8 SUB-000568-2018

NEWMAN CROSSING SUBDIVISION, RESUBDIVISION OF LOT 4

DETAIL SITE PLAN

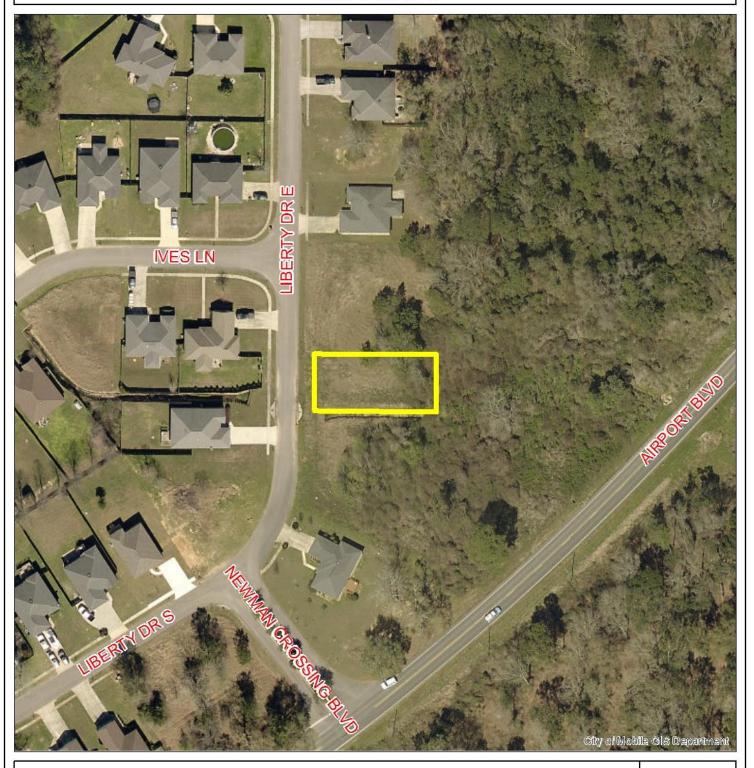
The proposed lot fronts Liberty Drive East, a minor street requiring a 50' right-of-way width. If approved, the 50' right of way width to Liberty Drive East depicted on the preliminary plat should be retained on the Final Plat.

When previously recorded, the lot had a single 10' drainage easement along the South property line. The preliminary plat illustrates a second 10' drainage easement along the North property line. If approved, a note should be placed on the Final Plat stating that no structure shall be erected in any easement.

The preliminary plat illustrates a 23' minimum building setback line along Liberty Drive West for the proposed Lot A. Staff has been informed that a dwelling was constructed on the site 23.4' from the front property line, thereby requiring a reduced front setback. Therefore, a waiver of Section V.D.9. of the Subdivision Regulations may be necessary.

In accordance with Section V.D.2. of the Subdivision Regulations, the proposed lot appears to meet the 7,200 square foot minimum lot size requirement for lots served by public water and sewer systems. The lot size information for the proposed Lot A is not provided. If approved, the lot size information should be provided in both square feet and acres on the Final Plat.

As a means of access management, a note should be placed on the Final Plat, if approved, stating that Lot A is limited to one curb cut each to Liberty Drive East, with the size, design and location of the curb cut to be approved by Mobile County Engineering and conform to AASHTO standards.

- 1) Retention of the 50' right-of-way width to Liberty Drive East;
- 2) Retention of the 23' minimum building setback line along Liberty Drive East for Lot A;

- 3) Provision of the lot size information in both square feet and acres on the Final Plat;
- 4) Placement of a note on the Final Plat stating that Lot A is limited to one curb cut to Liberty Drive East, with the size, design and location of the curb-cut to be approved by Mobile County Engineering and conform to AASHTO standards;

- 6) Placement of a note stating that no structures shall be erected in any easement;
- 7) Compliance with Engineering Comments and placement as a note on the Final Plat: (Must comply with the Mobile County Flood Damage Prevention Ordinance. Development shall be designed to comply with the storm water detention and drainage facility requirements of the City of Mobile storm water and flood control ordinances, and requiring submission of certification from a licensed engineer certifying that the design complies with the storm water detention and drainage facility requirements of the City of Mobile storm water and flood control ordinances prior to the issuance of any permits.); and
